Technical Service Bulletin: tsb100137

Turbocharger Bearing Coolant Plumbing

This Technical Service Bulletin updates the following procedure in the Troubleshooting and Repair Manual, QSK45 and QSK60 Series Engines, Bulletin 3666261:

Fig. 1, Turbocharger Coolant Supply and Drain Hose Mounting (high pressure)

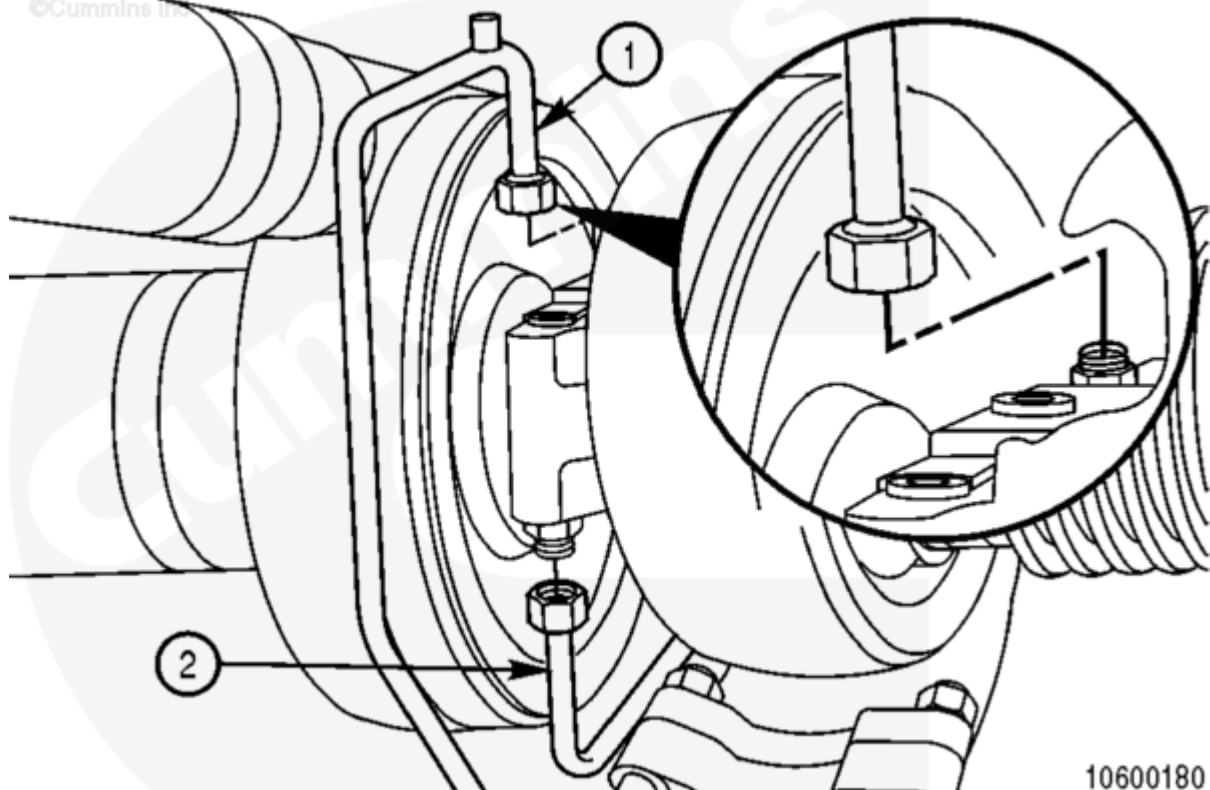
This Technical Service Bulletin highlights the importance of the turbocharger bearing housing coolant supply and drain hoses being mounted diagonally opposed to each other to provide adequate coolant flow around the turbocharger bearing.
